Proposed Jacket Foundation Project Option 1

Proposed Jacket Foundation Project Option 2

SITE: <b>NISA</b>		Building 3400 Avenue 3000 Cork Airport Business Park, Cork T12 AE76	<b>NISA</b> North Irish Sea Array	STATUS: <b>PLANNING</b>	
TITLE: Proposed Project Option 1 and Option 2 Front Elevation Comparison				REV:	DESCRIPTION:
SCALE AT A1: 1:1000		DATE: 10/02/2026	DRAWN: EG	CHECKED: JDUB	Approved: MJ
				D	A
				D	B
				D	C
				D	D
				Drawing No: 281240-NISA-OFS-OA-DR-PL-2005

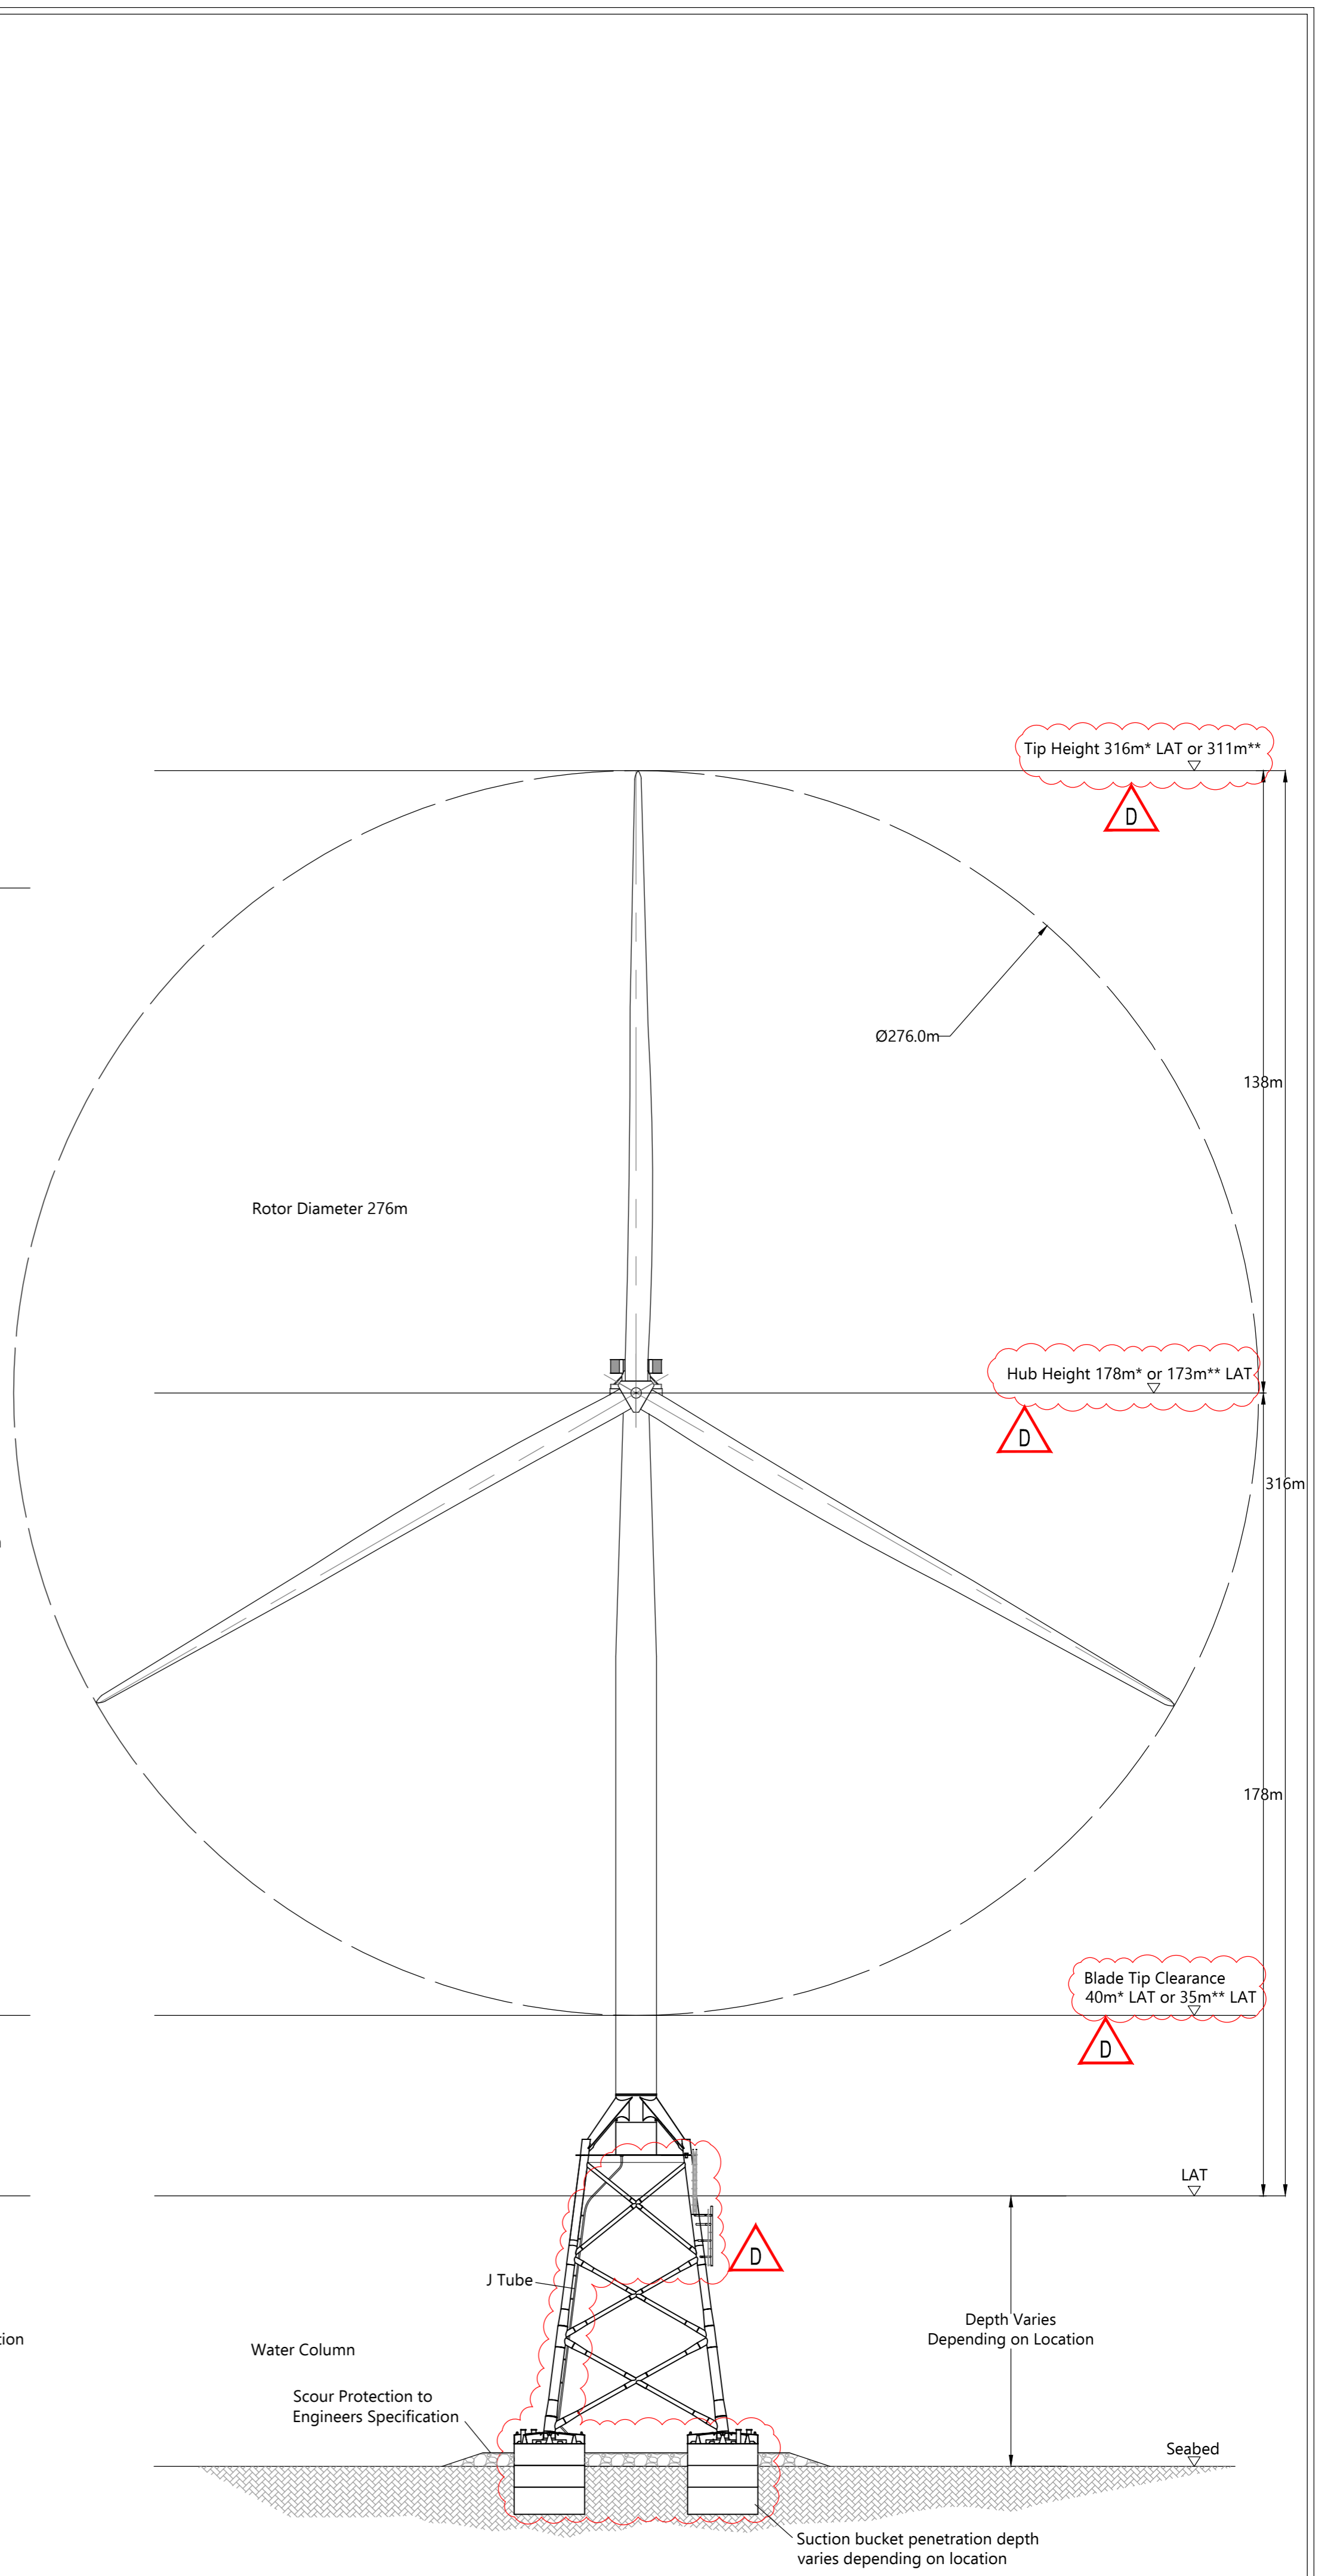
In response to Section 10 (a) of the RFI the Developer has proposed a refinement to the foundation types used for the wind turbine generators (WTGs) and offshore substation platform (OSP). Instead of either monopiles or jackets, only jackets will be used. Additionally, instead of installation with pin piles the jackets will be installed with suction buckets only for WTGs, and either jackets with suction buckets or jackets with drilled pin piles will be used for the OSP.

The Developer notes an administrative error in the planning drawings submitted alongside the 2024 EIAR that did not include the J-tube in the elevation drawings for the jacket foundations. This has now been included to illustrate where the array cables will connect the WTG and OSP to the seabed.
